Loreto Kirribilli
IPC Briefing
11th September 2018

Loreto Kirribilli IPC Briefing DoP Conditions for discussion

Loreto Kirribilli Development Consent Condition B5 - Building Design

Revised SSD Scheme

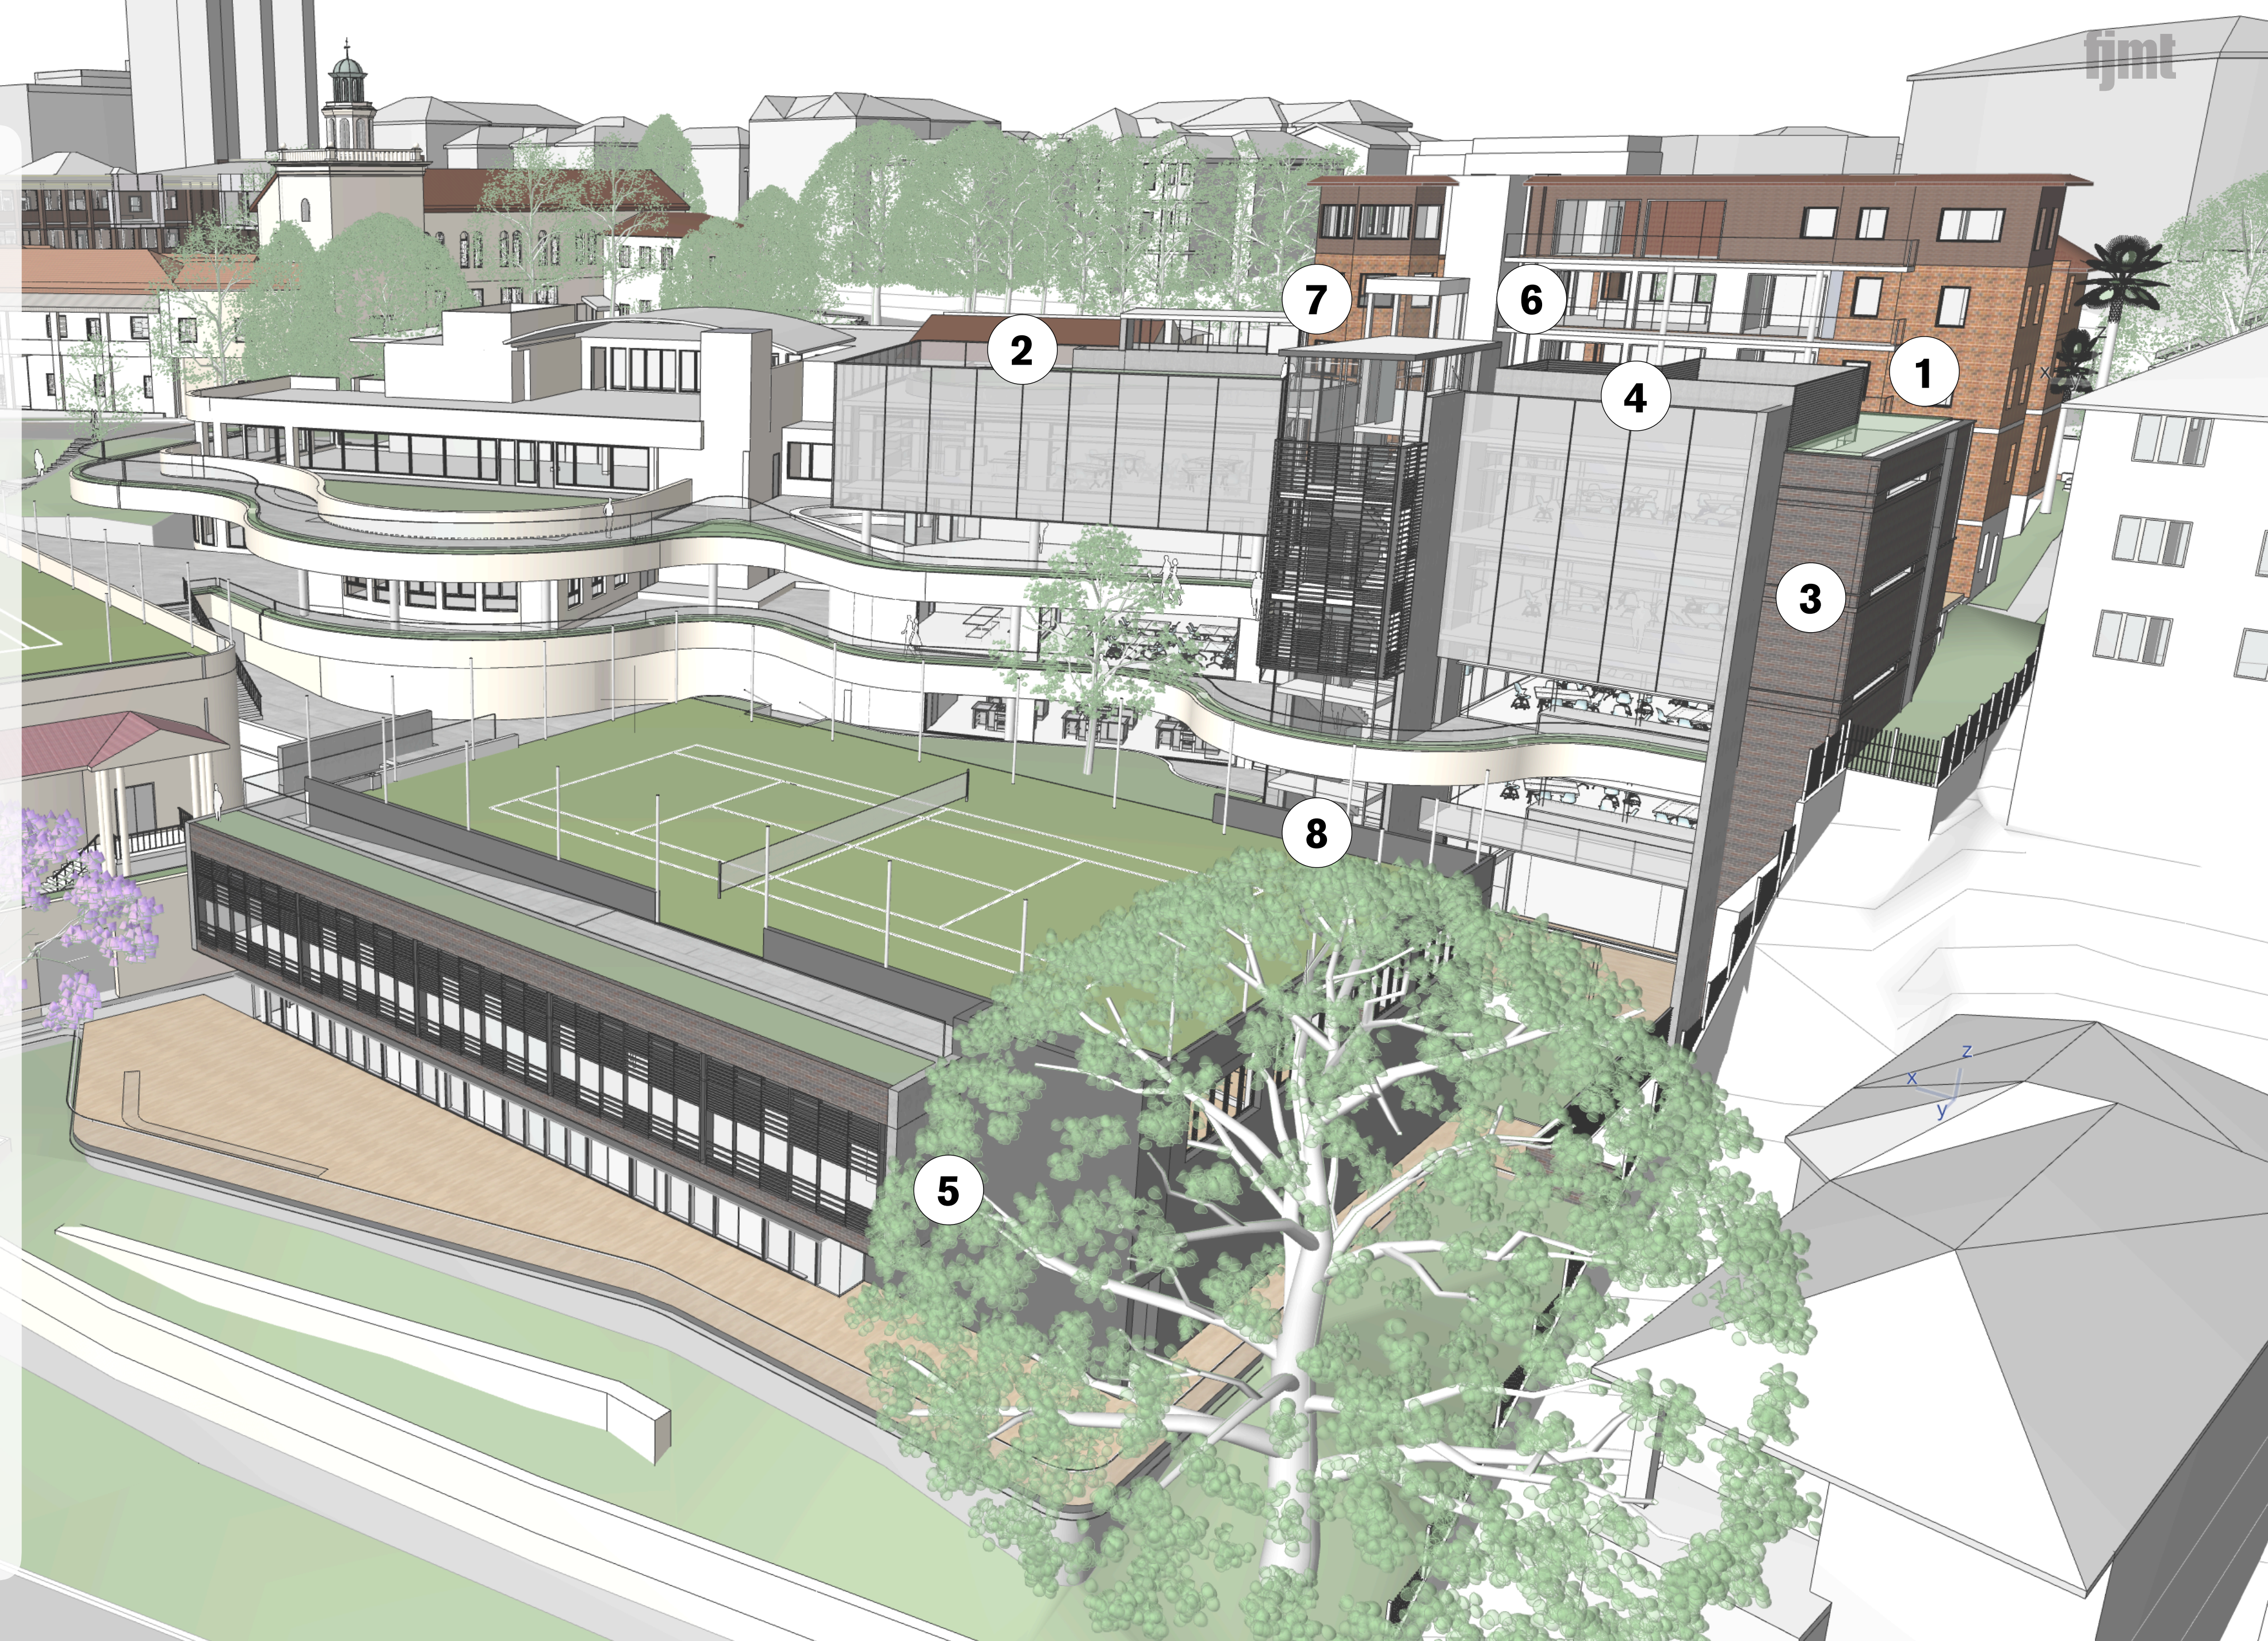
- 1** Parapet reduced in height
Integrated planter
creating a landscape
buffer to 111 Carabella St
- 2** Increased Roof Garden
(Reduced trafficable
area)
- 3** Western boundary
facade articulation;
Introduced high level
windows and brick
detailing
- 4** Relocated Mechanical
Plant - Acoustically
treated
- 5** Building setback to
improve access to light
and air - 22 Elamang
- 6** Louvred roof removed
- 7** Glazed Lift
- 8** Reduced bulk and
scale of connector
form

SSD Revised Scheme

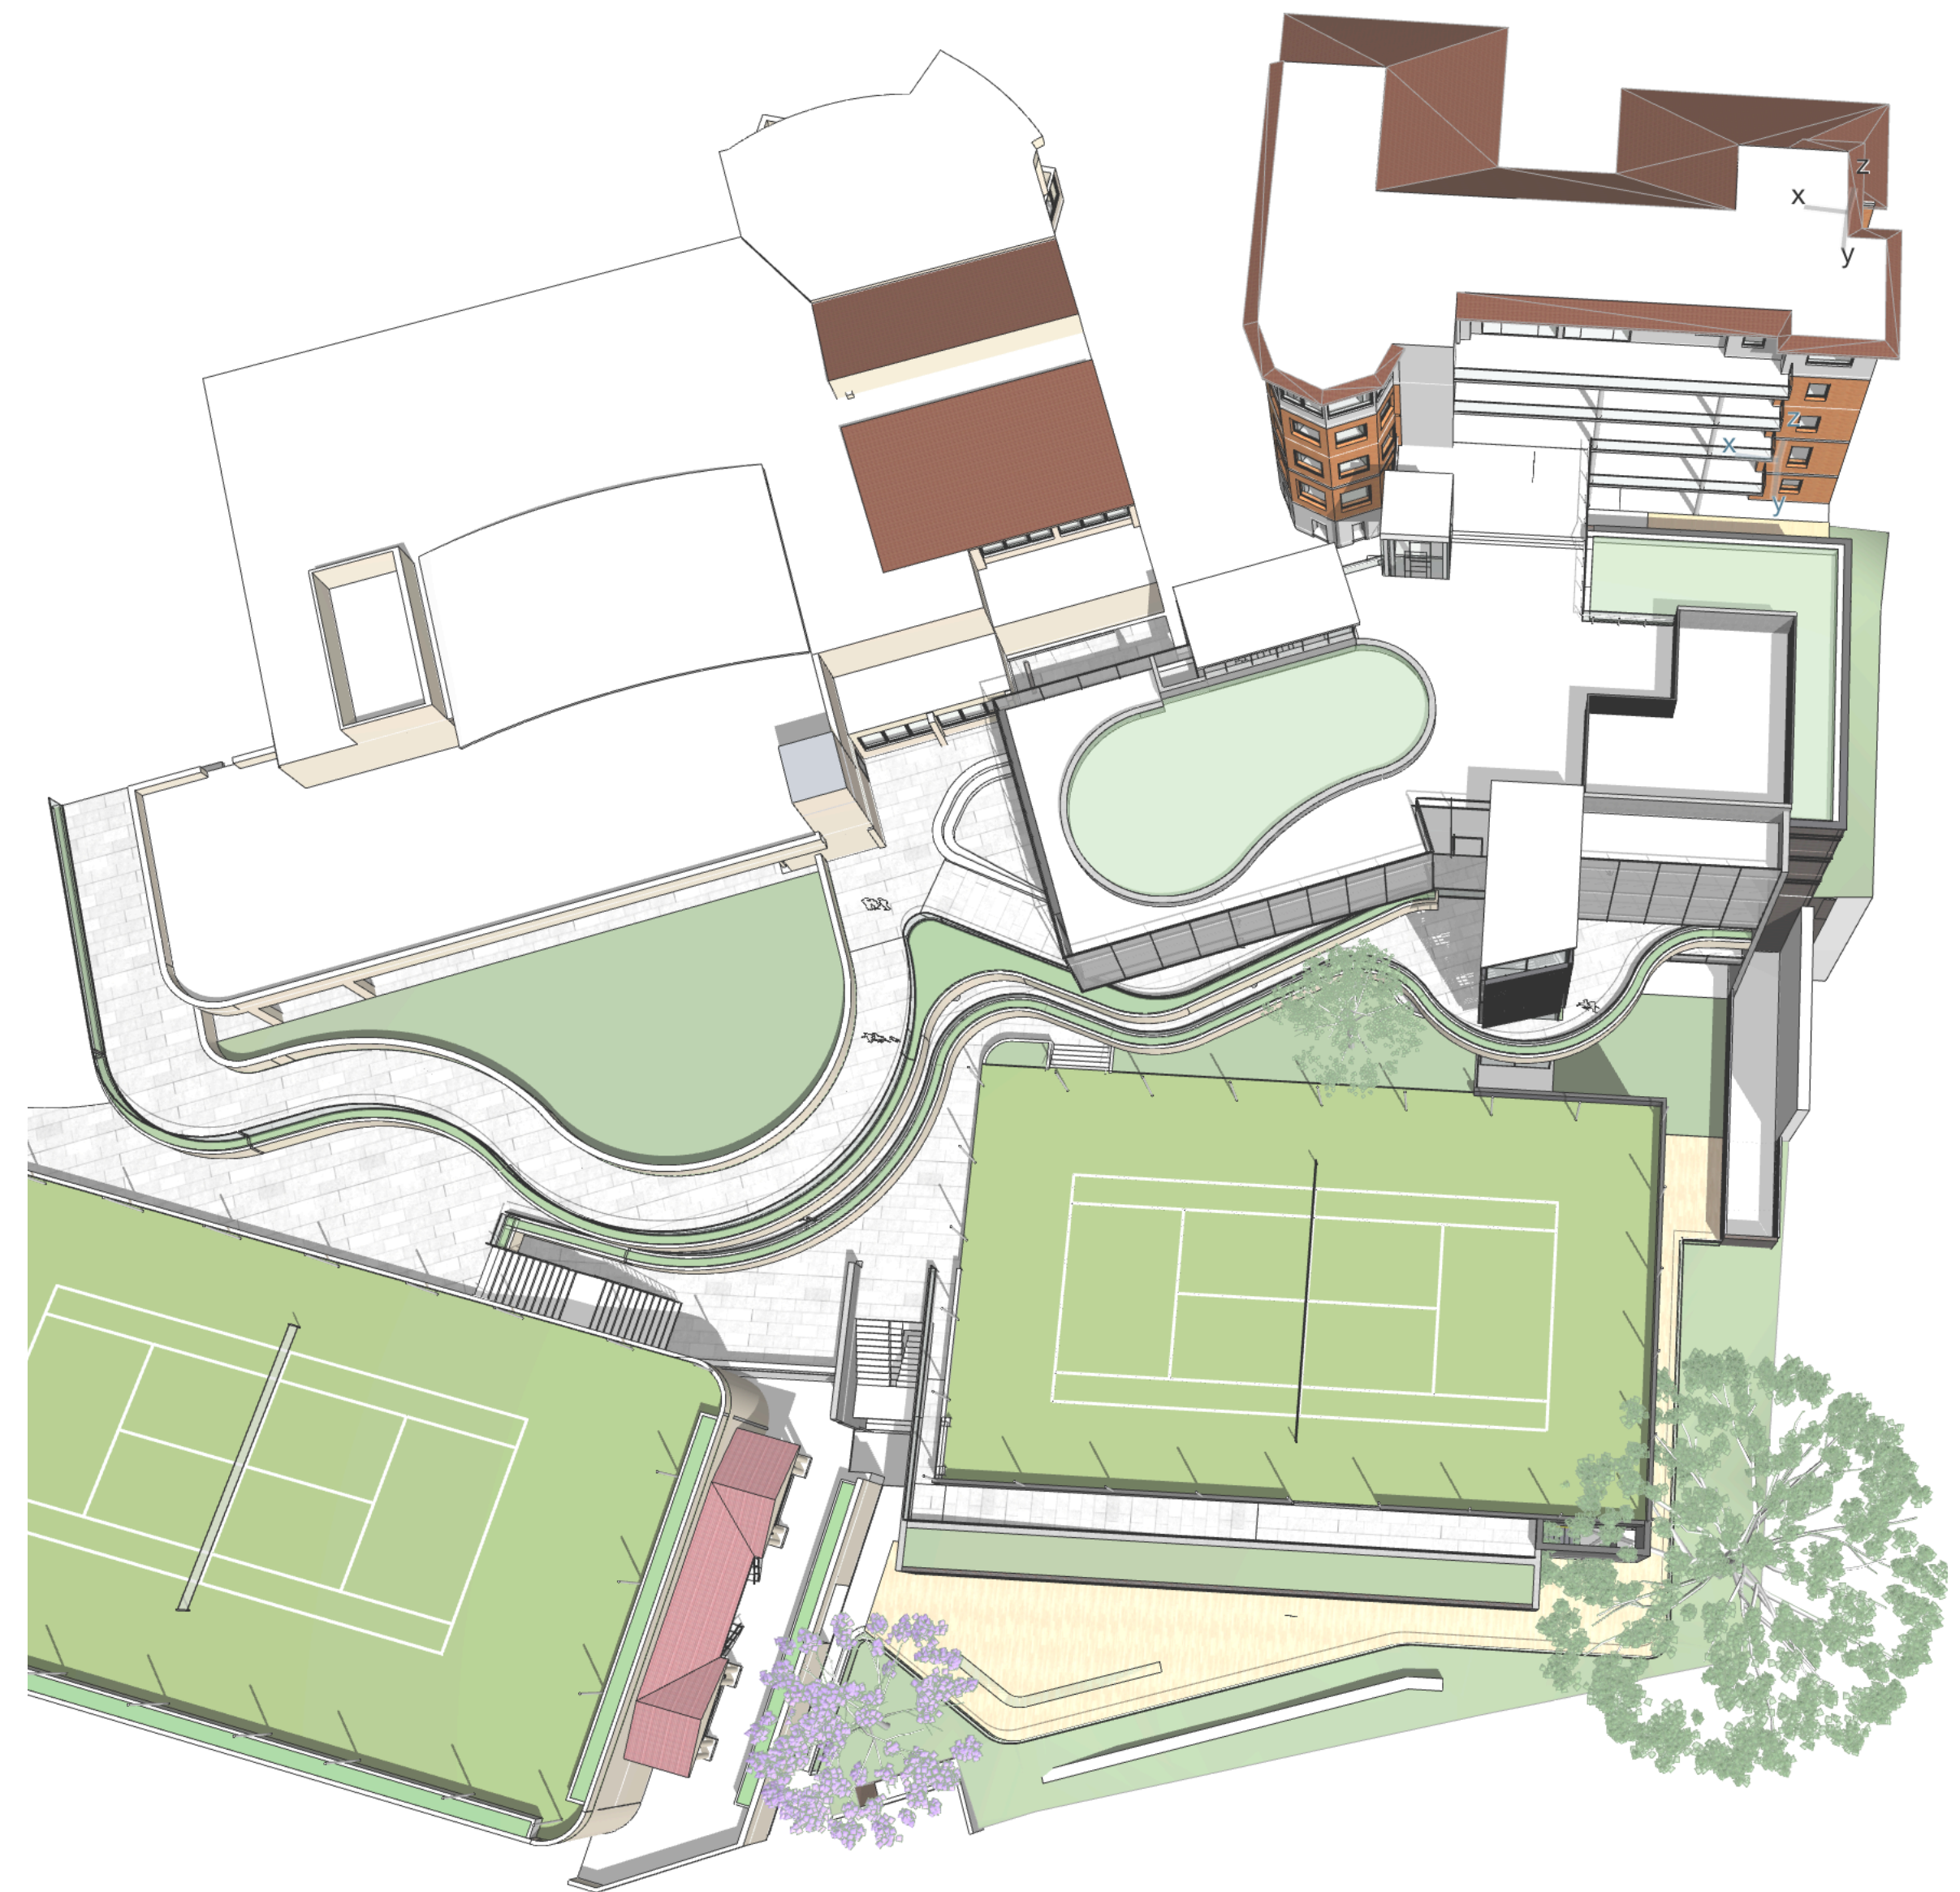
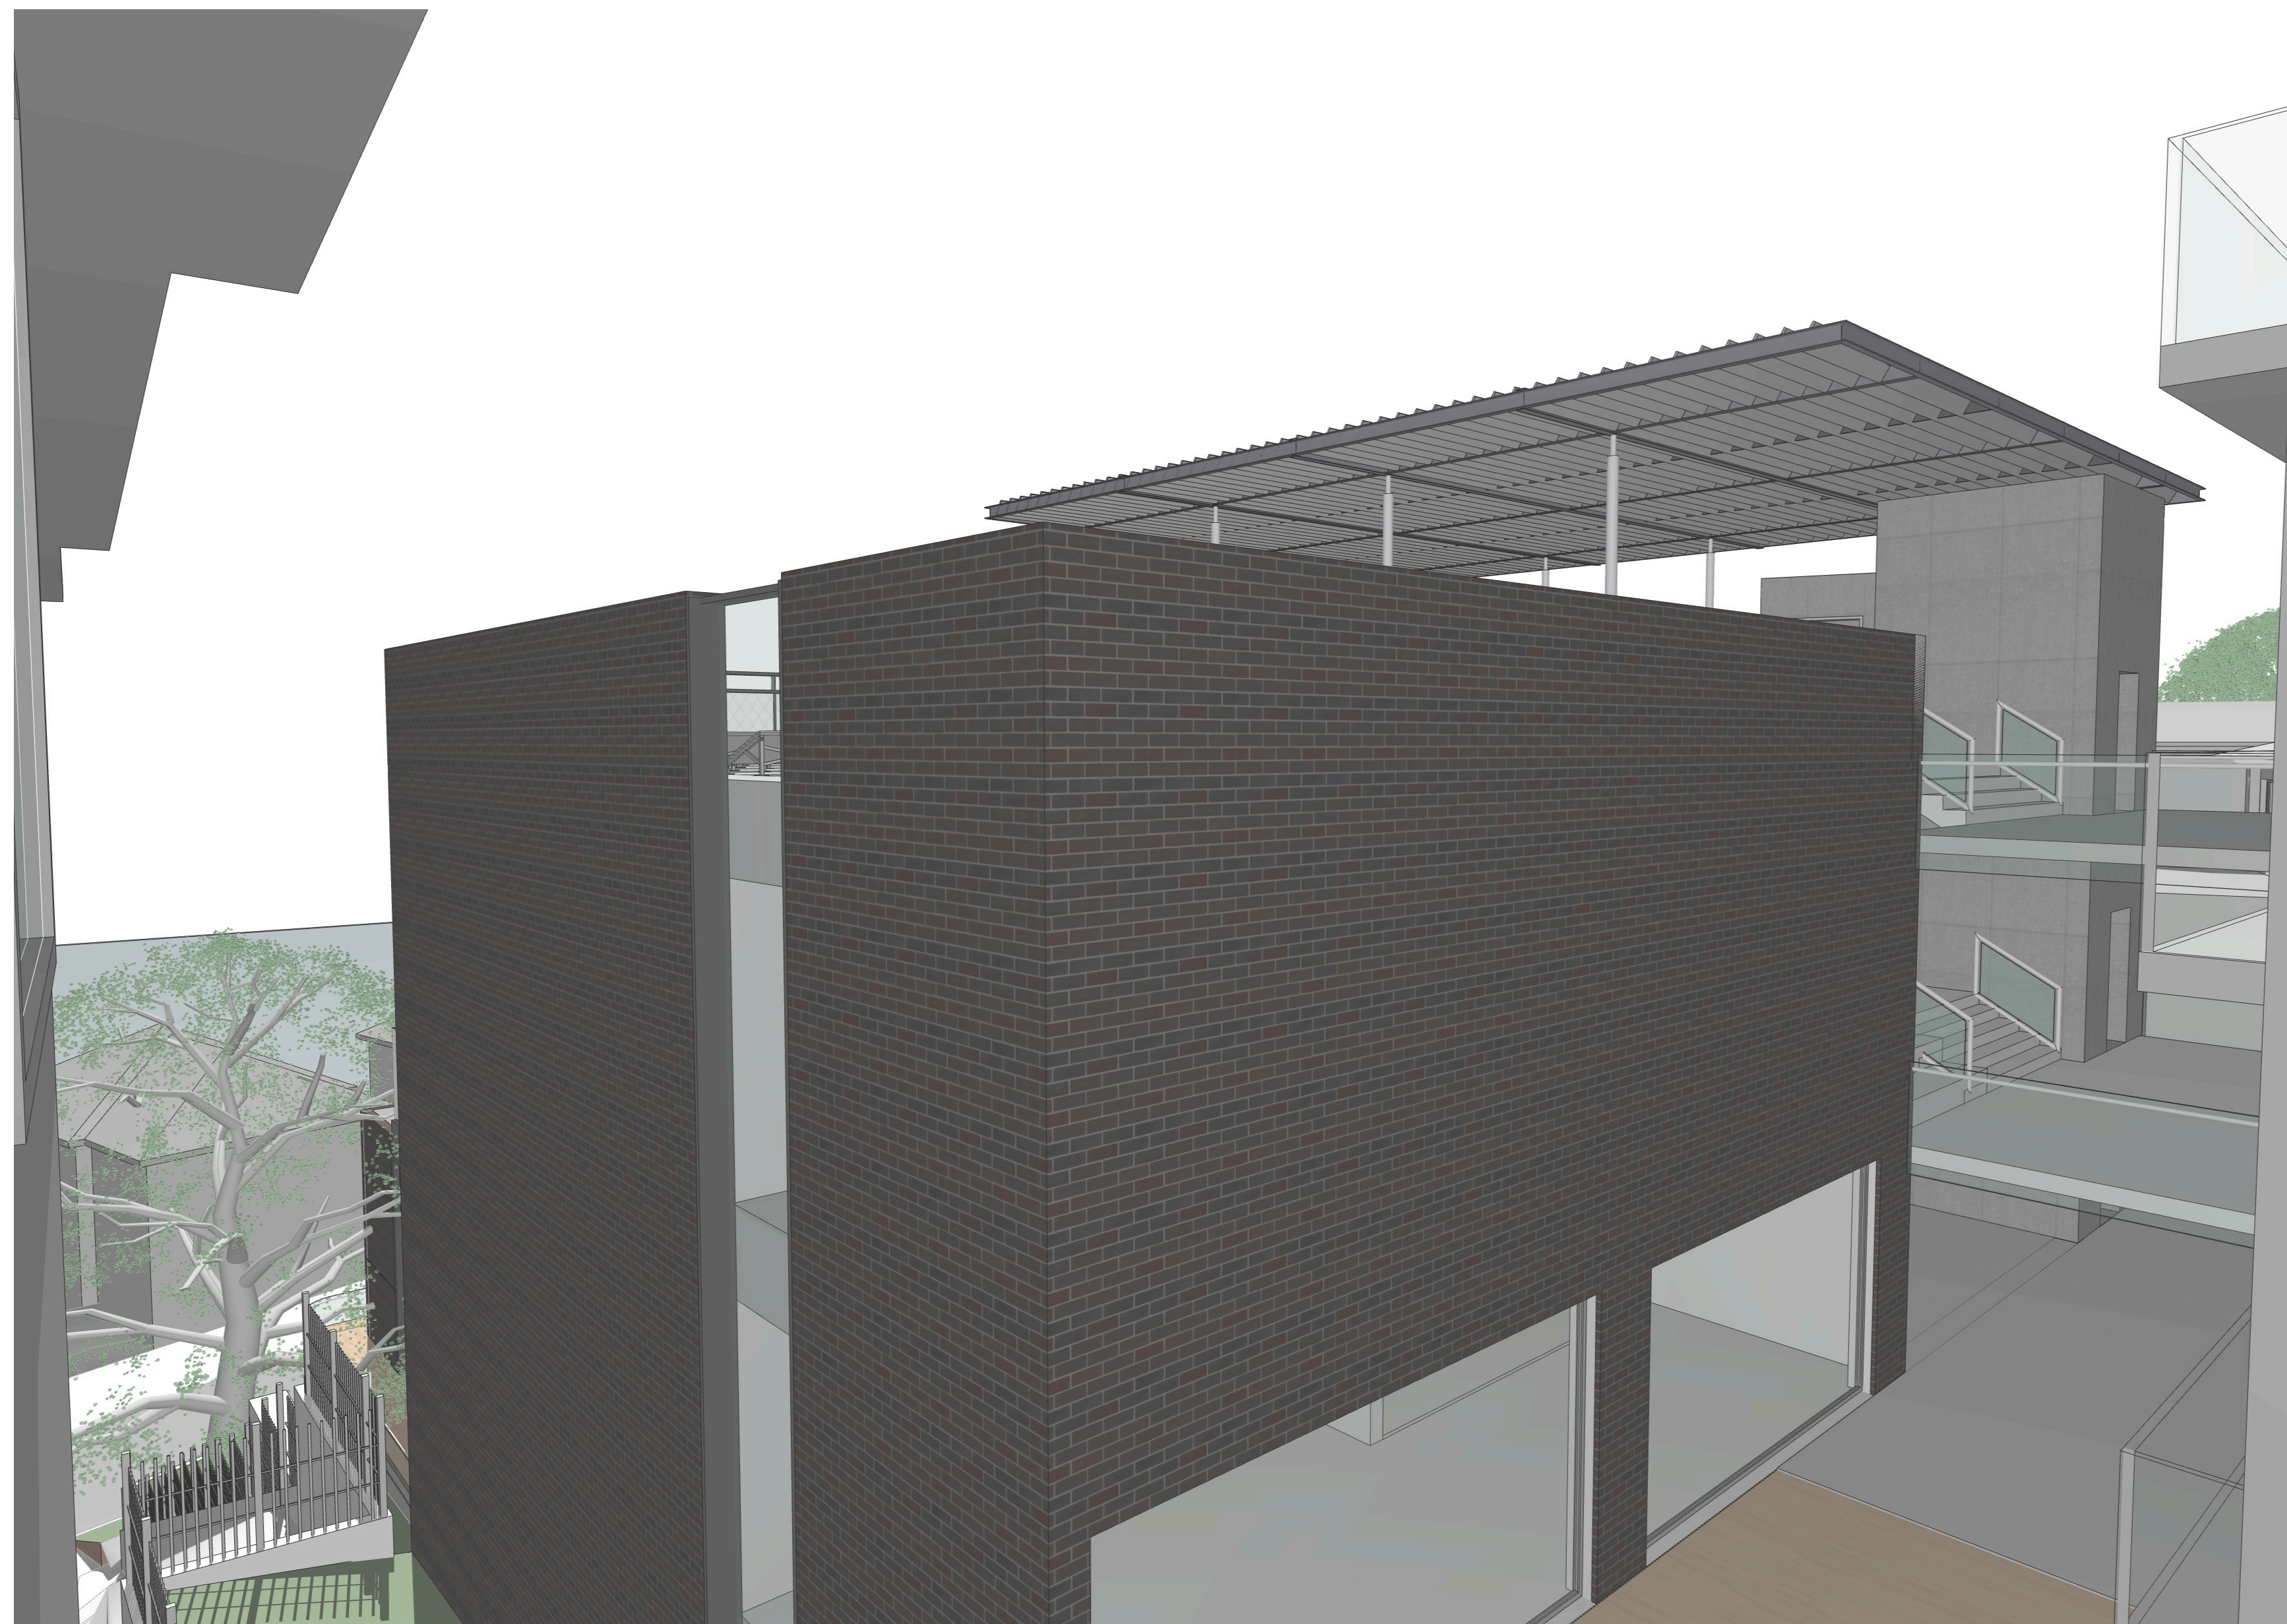
- 1** Parapet reduced in height
Integrated planter
creating a landscape
buffer to 111 Carabella St
- 2** Glazed lift
- 3** Introduced high level windows
and slot windows
- 4** Privacy screen
- 5** Brick detailing
